Re: Objection to Application for Planning Permit TP-2017-883 | 93-103 Park Street, South Yarra

On behalf of our client group, we object to the proposed demolition of the buildings on the site and the development of a four storey apartment building with roof top terraces at 93-103 Park Street, South Yarra.

Figure 1: Red outline depicting covered areas included in the garden area calculation

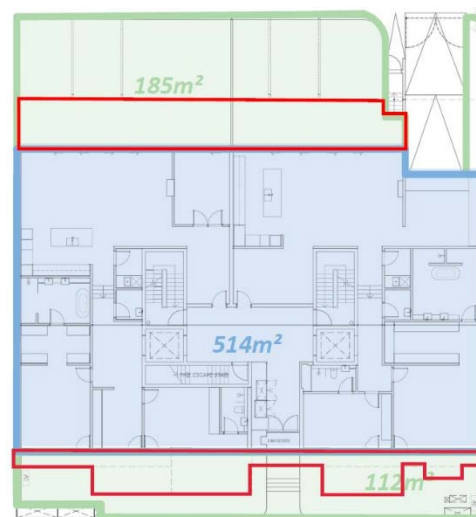
The building façade, window and balcony projections which create 'covered areas' have been included in the calculation for Garden Area, as demonstrated in Figure 1 (extracted from the architectural drawings). The covered areas included in the green shaded areas of Garden Area in the calculation are highlighted by the red outline.

The definition of what constitutes Garden Area in the Planning Scheme is clearly centred on the space being outdoors and uncovered. On this basis, the calculation of the Garden Area provided in the proposed development is not accurate. The minimum requirement of 35% of the area of the site is not satisfied when all covered areas are included in the calculation. Accordingly, the mandatory requirement of 35% of the area of the site being set aside as Garden Area is not met.

On this basis, we submit that the application cannot be further considered until this mandatory requirement is satisfied.
